Project	IEEE 802.16 Broadband Wireless Access Working Group < http://ieee802.org/16 >	
Title	Proposed Clarifications regarding Irregular Sub-frame	
Date Submitted	2008-05-05	
Source(s)	Lei Wang, Roger Marks NextWave Wireless Inc.	E-mail: lwang@nextwave.com rmarks@nextwave.com * http://standards.ieee.org/faqs/affiliationFAQ.html >
Re:	IEEE 802.16m-08/016r1 (“Call for Contributions on Project 802.16m System Description Document (SDD)”)	
Abstract	This contribution proposes clarifications about the irregular subframe and its usage.	
Purpose	To be discussed and adopted by TGm in the 802.16m SDD IEEE 802.16m-08/003r1.	
Notice	<i>This document does not represent the agreed views of the IEEE 802.16 Working Group or any of its subgroups. It represents only the views of the participants listed in the “Source(s)” field above. It is offered as a basis for discussion. It is not binding on the contributor(s), who reserve(s) the right to add, amend or withdraw material contained herein.</i>

Proposed Clarifications regarding Irregular Subframe

Lei Wang, Roger Marks

NextWave Wireless Inc.

Figure 9: Regular and Irregular sub-frames in TDD duplex scheme (CP=1/8 T_u)

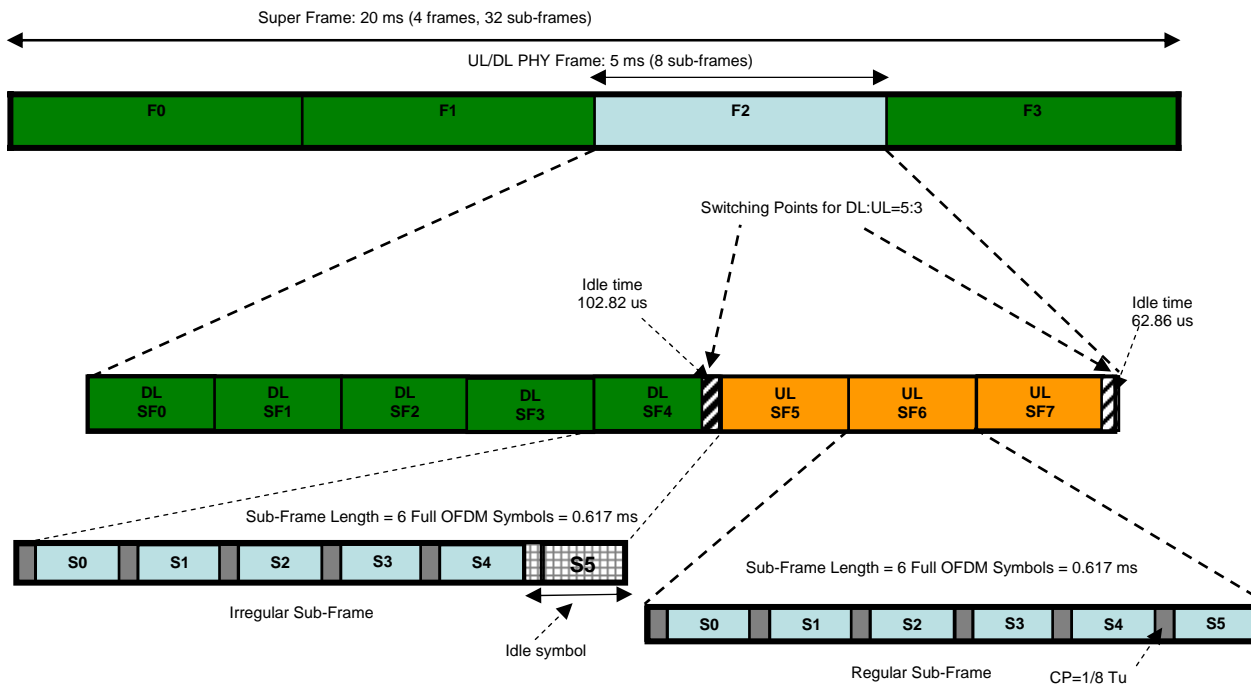
- 1) On page 17, in section 11.4.1, line 13 specifies an irregular subframe consists of five or less symbols, however, in Figure 9 on page 19, the irregular subframe, DL SF #4, appears as the same size as the regular subframes. In fact, it appears that the irregular subframe is *longer*, not shorter, than a normal subframe, because DL SF #4 is followed by a hashed rectangle that is not explained in the figure or text.

- 2) One end of the right dotted line of the irregular subframe in Figure 9 shows the grey-shadowed box is part of the irregular subframe, while the other end shows the opposite way; i.e., the grey-shadowed box is *not* part of the irregular subframe.

- 3) On page 22, lines 1 to 3 describe how the idle symbol is used to provide the needed gap at a switch point in TDD systems. In Figure 9, the irregular subframe is clearly used for this purpose. However, the explanation from page 22 needs to be moved to section 11.4.1, where the irregular subframe is introduced. Also, the definition and use of the irregular subframe needs to be explained and made consistent. Is it a shortened subframe, or a full-length subframe in which the last symbol is an idle symbol? And, if the definition in 11.4.1 is corrected to refer to idle symbols, then we need clarification as to *which* of the six symbols may be idled.

Figure 9 illustrates an example TDD frame structure with DL to UL ratio of 5:3. Assuming OFDMA symbol duration of $102.82 \mu\text{s}$ and a CP length of $1/8 T_u$, the length of regular and irregular sub-frame are 0.617 ms ~~and 0.514 ms , respectively~~. In Figure 9, the last DL subframe, i.e., DL SF4, is an irregular sub-frame whose last OFDMA symbol is an idle symbol to accommodate the gap required to switch from DL to UL. Other numerologies may result in different number of sub-frames per frame and symbols within the sub-frames. Figure 10 shows the frame structure in FDD mode.

On page 17, replace the Figure 9 by the following Figure:

With such a usage of the irregular subframe, let's fix the inconsistency between Figure 9 and text in line 2 to 4 on page 22 by defining the irregular subframe as 6 symbols long but having one or multiple idle symbols at the end. In this way, the fixed interval of 0.617 ms, i.e., a subframe, is kept consistent in the frame structure. The irregular subframe is a special case of a subframe.

There are two types of sub-frames: 1) the regular sub-frames which consist of six [active](#) OFDMA symbols and 2) the irregular sub-frames that consist of ~~five or less~~ [six](#) OFDMA symbols [in which one or multiple OFDMA symbols is idle, where the active OFDMA symbol is transmitted with modulated signals, and the idle OFDMA symbol is not transmitted](#) .
